**Item 3.****Development Application: 410 Pitt Street, Haymarket - D/2020/1387**

File No.: D/2020/1387

**Summary**

**Figure 27:** View loss study section illustrating devastating view loss to apartments on levels 33 to 36

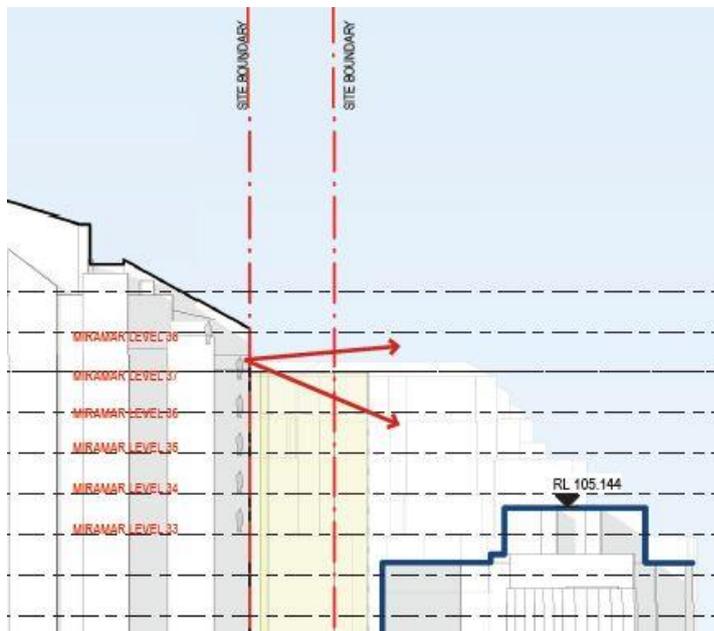
52. The considered view loss study demonstrated that view loss to apartments on levels 33 to 36 would be total loss of views to the south. Views from apartments on levels 37 and 38 were retained with some affectation as shown in the images below.

**Figure 32:** Amended north elevation plan (left) and building envelope east west section plan D/2015/661/B (right)

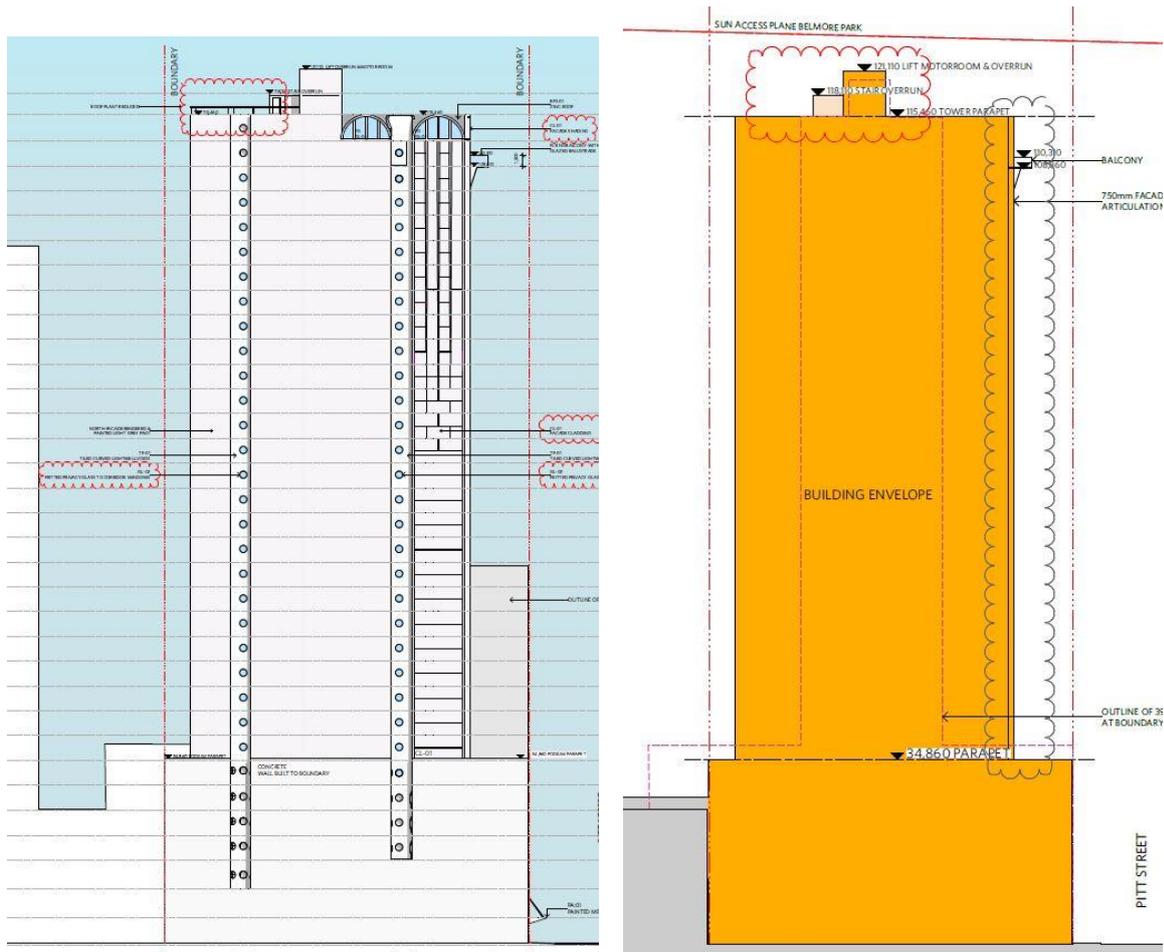
54. A view loss study was submitted as part of requested additional information for assessment of the application. As a result of feedback from the assessment of the view loss study and onsite inspections of a number of the affected upper level apartments of the 'Miramar' building, the application was modified to reduce the lift and stair overrun area. The application as amended is shown in the images below.

**Figure 34:** View loss study images western facing apartment level 37, proposal as amended

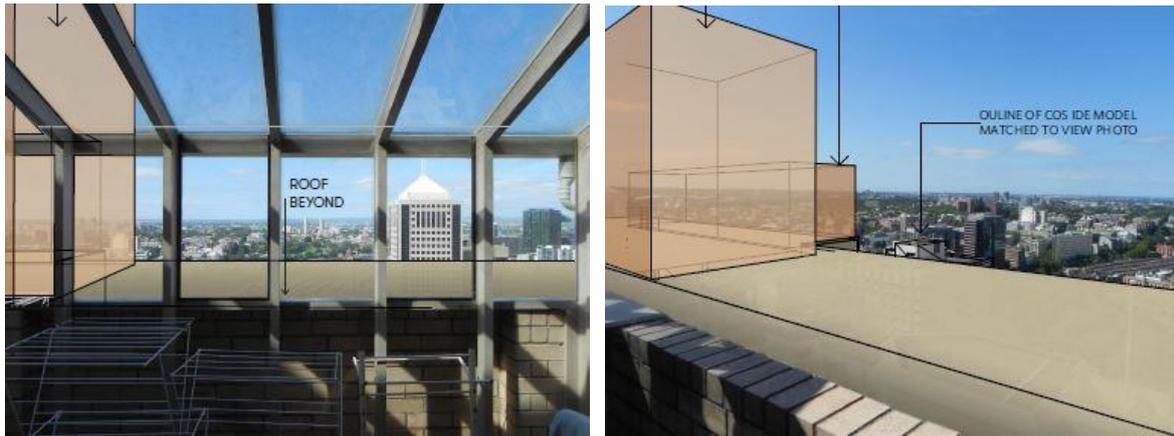
59. On level 38 district and water views are retained for both east and west facing apartments with the central lift overrun obscuring some elements of the view. The additional view loss is rated as minor.
60. On level 37 from the east-facing apartment, district views to the southeast are retained. Views from the wintergarden and living area are impacted as shown in Figure 33. Views to the southeast are retained with views to the south impacted. The additional view loss is rated as moderate.
61. On level 37 from the west-facing apartment, views from the wintergarden, living area and balcony to the southeast are impacted, views to the south are retained as shown in Figure 34. The additional view loss is rated as minor.

64. In conclusion, the proposal as amended is considered to provide an acceptable level of view loss impact with reference to the matters to be considered within the view loss planning principle.

**Figure 35:** Typical floor plan levels 7 to 29 with location of wintergarden windows on adjoining building dashed

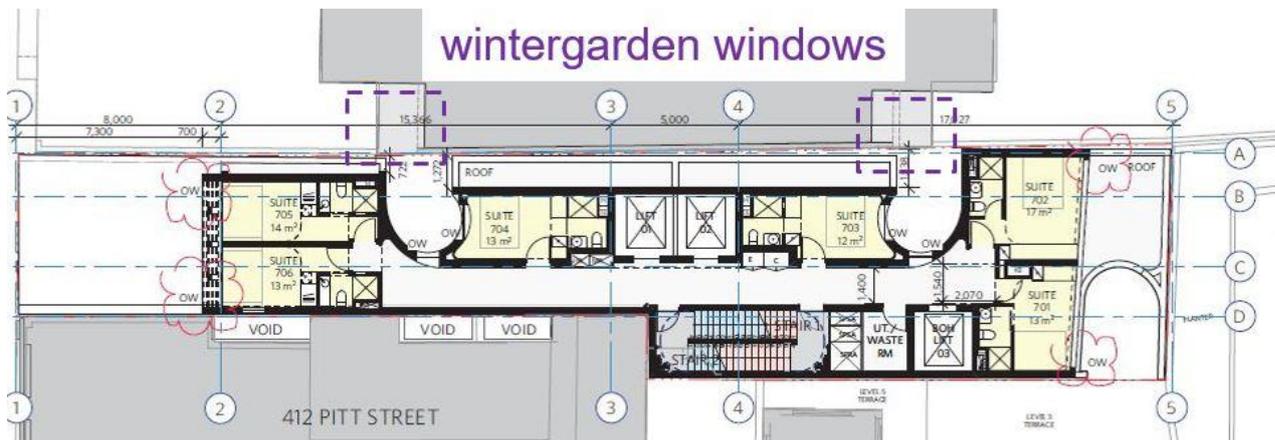
- Wind tunnel testing
  - Visual privacy details
  - Glazing details
  - Landscaping
69. The provided details are considered to address the majority of design issues raised. Visual privacy from corridor windows remains one outstanding issue. Operable windows are located within the lightwells at each end of the corridor within proximity of the south-facing corner windows of the Miramar apartment building to the north as shown on the typical level 7 to 29 floor plans in the figure below.

70. These windows are proposed to include fritted glass as a privacy measure and also allow for light to the corridor. Details of the operability of the windows are not included and may result in privacy impacts to the adjoining building where windows are in the open position. It is recommended that further design details be provided as a condition of consent to ensure privacy will be retained whilst any windows are opened.
